ALERT SERVICE BULLETIN

UH-1H-11-06

Revision A, 2 August 2011

SUBJECT: MAIN ROTOR HEAD INBOARD FITTING 204-012-102-005, INSPECTION OF SPECIFIC SERIAL NUMBERS.

FIGURE 1

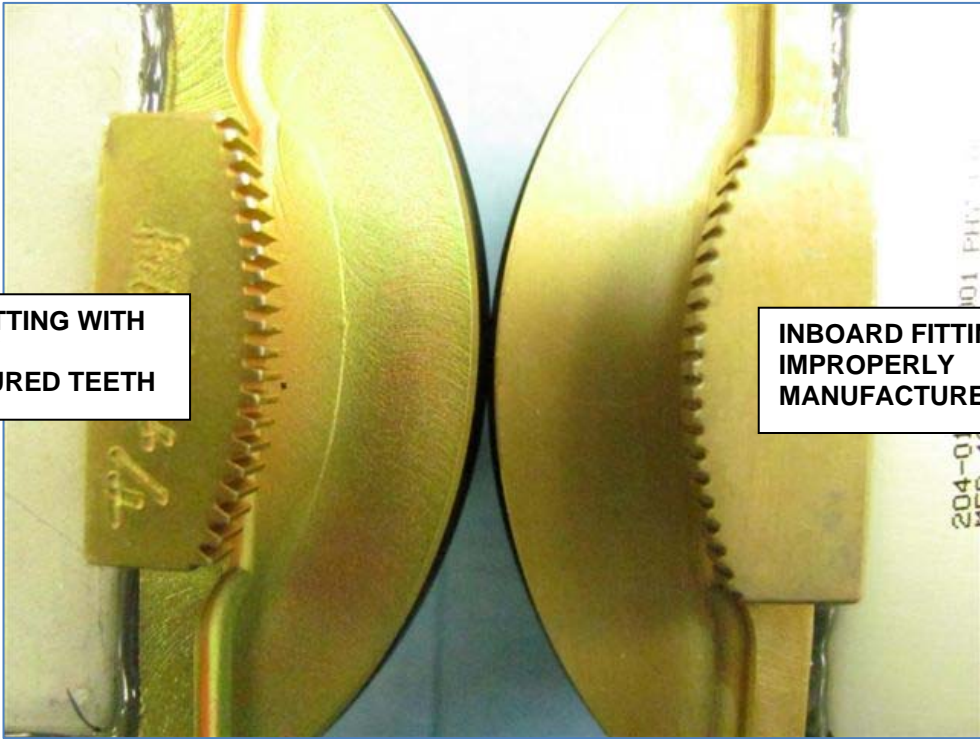
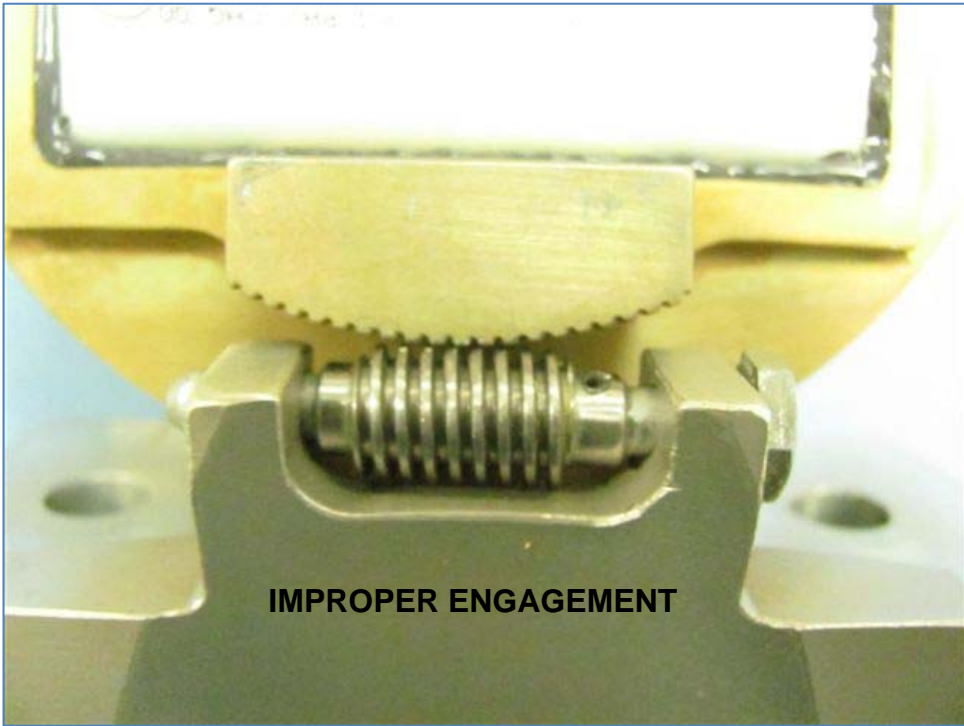
1. Prepare helicopter for maintenance.
2. Flap the main rotor to obtain clearance between the static stop and the mast. Secure the blade as required to prevent movement.
3. Clean worm gear 204-012-109-001 and the inboard strap fitting as required to visually inspect the engagement of the worm gear with the inboard strap fitting.
4. Refer to Figure 1. Inboard fittings with incorrect thread depth will not fully engage the worm gear. Using an inspection mirror, visually inspect fitting and verify full engagement of the worm gear with the inboard fitting. Full engagement means contact of both flanks of the worm gear with both flanks of the inboard fitting teeth for the most fully engaged mesh. The flank of the gear can also be described as the contact face that contacts the opposing face of the inboard fitting thread. There may

be a gap between the top (Major Diameter) of the worm gear and the base (Minor Diameter) of the strap fitting of up to 0.009 inch.

IMPROPER ENGAGEMENT

If bolt does not rotate, the fitting is acceptable and no further inspection is required, proceed to step 9. If bolt rotates, but the fitting engagement is correct, inspect worm gear and fitting teeth for possible damage. If no damage is found proceed to step 9.

5. If visual inspection determines the fitting gear is not defective and engages the worm gear per paragraph 4, verify that the worm gear does not turn by placing a torque wrench on the worm gear bolt and apply 10 to 15 inch pounds of torque. The bolt should not turn under the applied torque.
6. Repeat this procedure for the opposite side of the main rotor head.
7. If either the worm gear is not fully engaged or the worm gear turns under the applied torque then the inboard strap fitting is suspect of being dimensionally discrepant in the thread area. All discrepant strap fittings are non-airworthy and are to be removed from service.
8. Replace all discrepant strap fittings with new or serviceable fittings in accordance with DMWR 55-1560-196.
9. Make an entry in helicopter historical service records indicating compliance with this Alert Service Bulletin.
